ILLINOIS POWER COMPANY

May 25, 1984

Subject: Clinton Power Station Unit 1
SER Confirmatory Issue No. 71
Humphrey Concerns

Illinois Power Company letter dated June 17, 1983 (refer U-0644) addressed some of the John Humphrey concerns as applicable to the Clinton Power Station (CPS). Enclosed are CPS responses on some additional Humphrey issues for NRC Staff review. Included are Action Plans #5, 6, 8, 21 and revised responses to Action Plans #2 and 3. We believe that these responses will resolve the particular concern involved.

Figure 3-8: CLINTON FSAR BASE CASE POOL SIMULATION

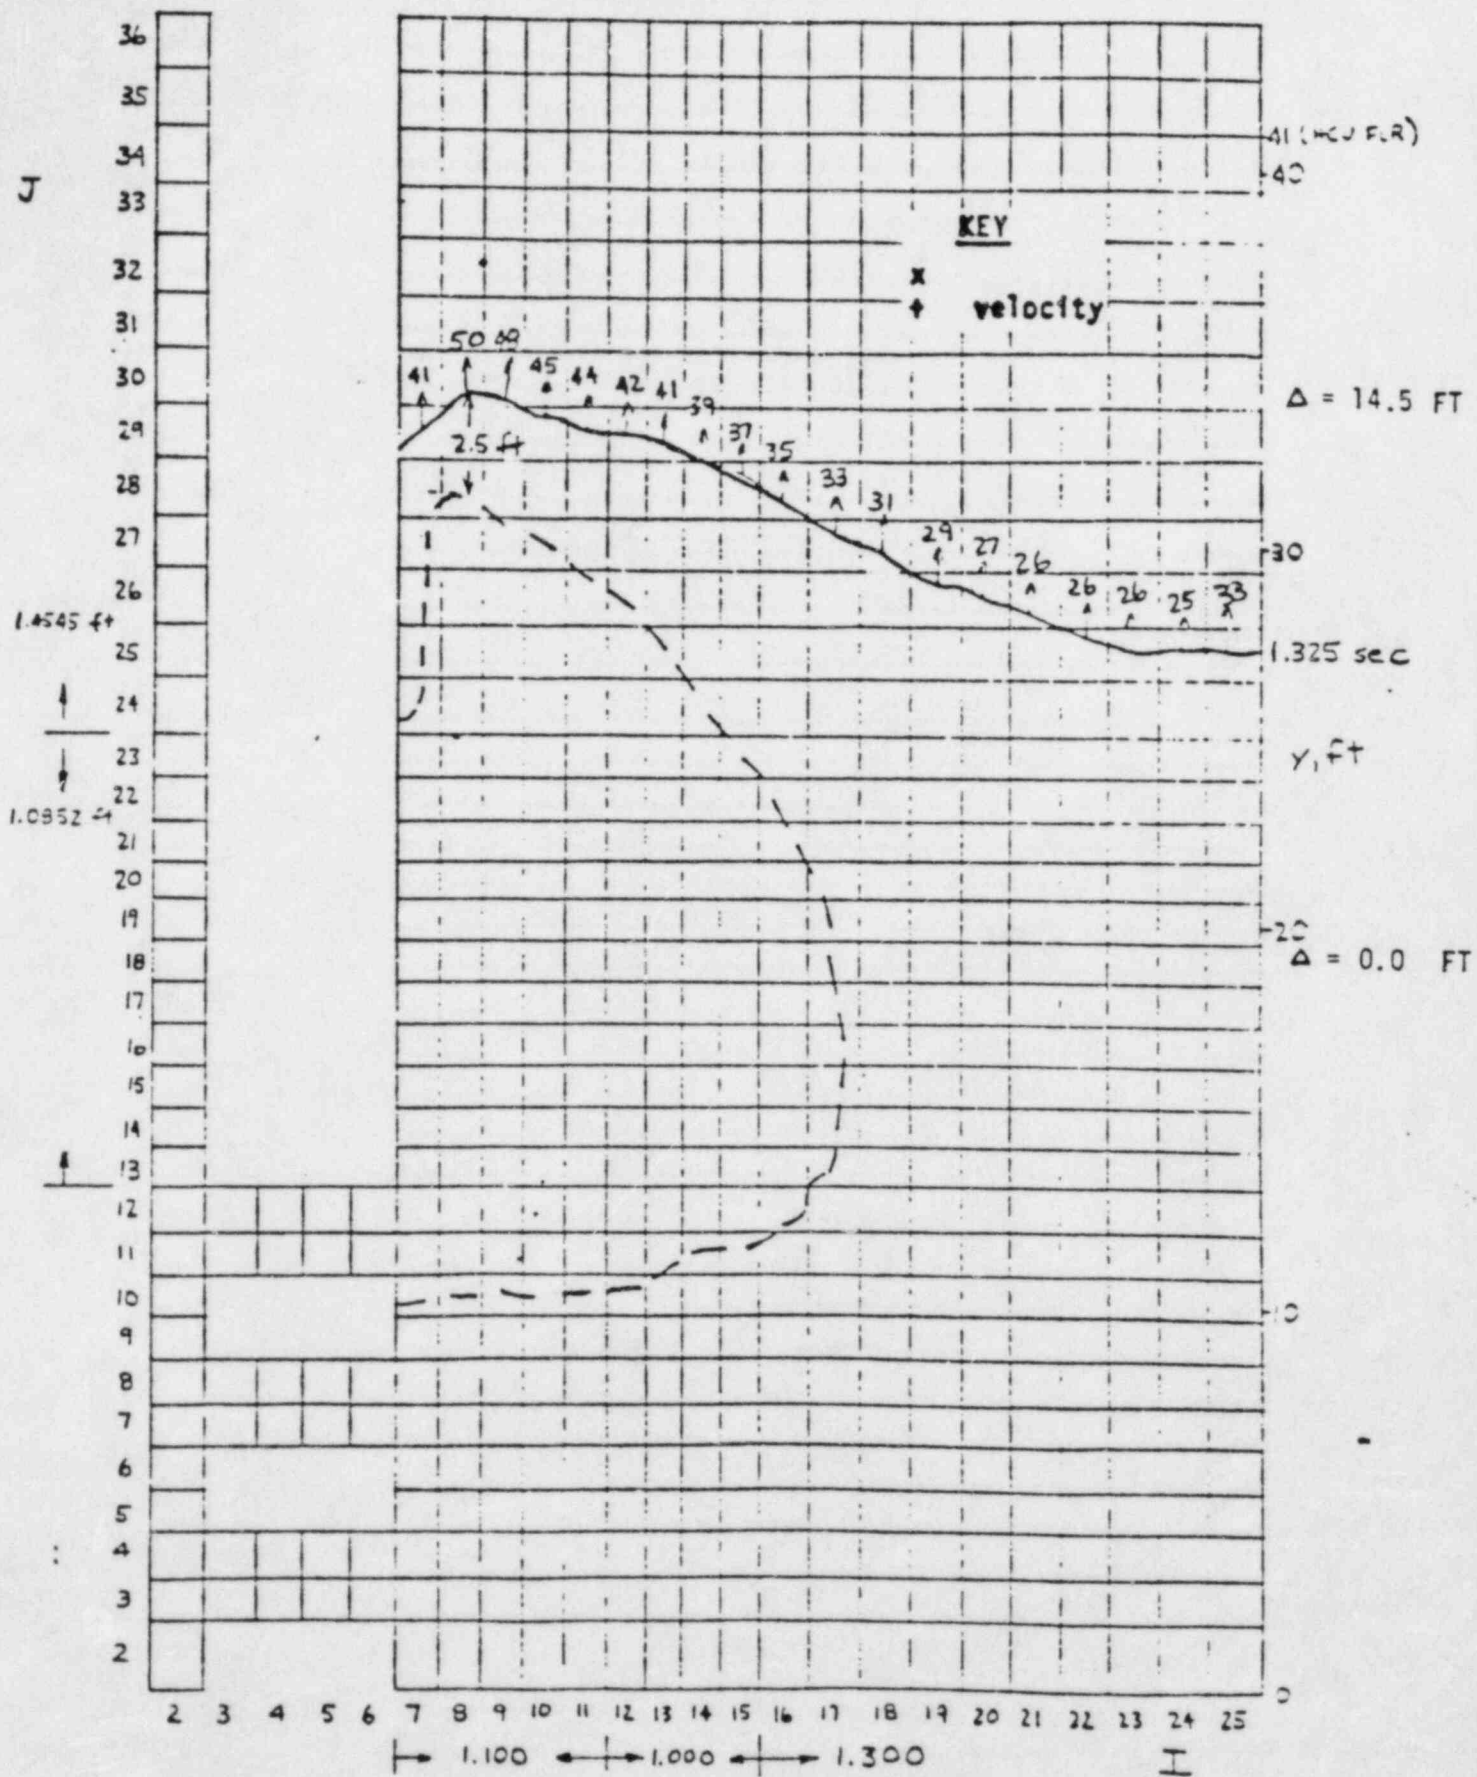
Since there is no encroachment beneath the main steam tunnel and since Figure 3-8 (Clinton FSAR Base Case Pool Simulation) shows breakthrough at 14.5 feet above the initial pool surface, the original GESSAR II impact loads still apply.

Figure 8.1. Schematic of Clinton RHR Heat Exchanger

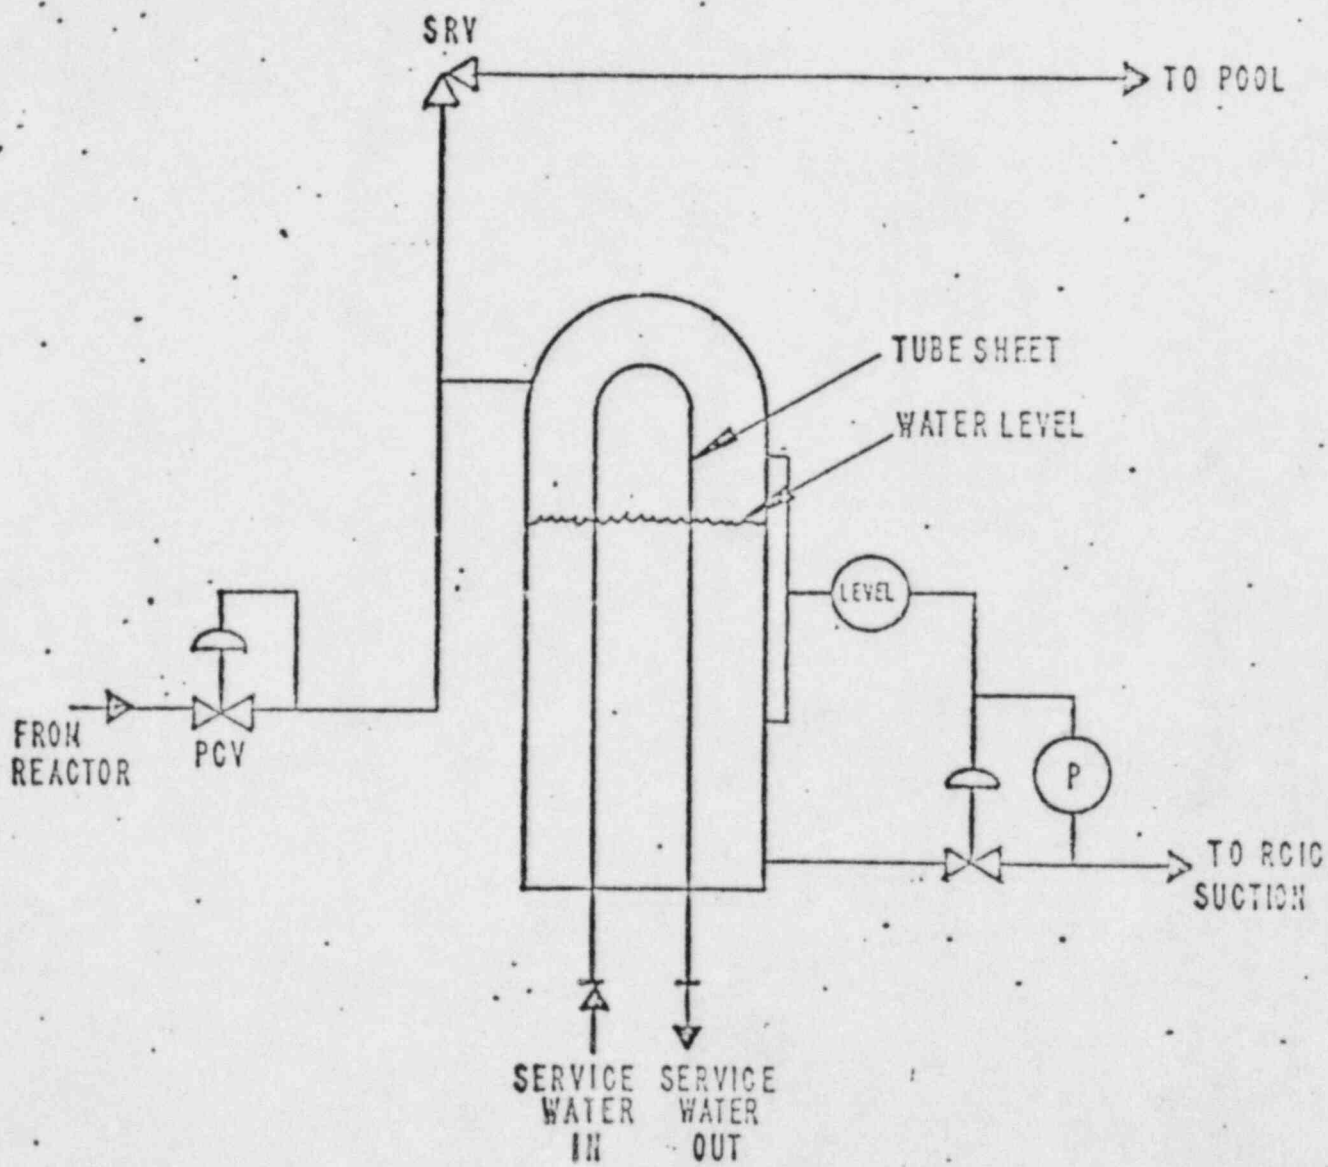
A schematic of the RHR in SCM is shown in Figure 8.1. The steam flow into the RHR heat exchanger is controlled by a pressure control valve (PCV) that is set to maintain a desired pressure in the RHR heat exchanger. The Clinton Power Station RHR system design does not have non-condensable bleed lines running between the RHR heat exchangers and the relief discharge lines. This fact makes the Clinton RHR system design different from both Perry and Grand Gulf designs. The only way that steam flow into the Clinton RHR relief discharge line can occur is through the safety relief valves (SRV) that are provided to prevent over-pressurization of the RHR heat exchangers. The various scenarios leading to steam flow through the discharge line are discussed below.

In this scenario it is postulated that a mechanical failure of the PCV (see Figure 8.1) occurs and it pops open as soon as the steam block valve from reactor is opened. The RHR heat exchanger will pressurize rapidly to the SRV set point. At this point, the SRV will open and discharge steam to the suppression pool through the discharge line.
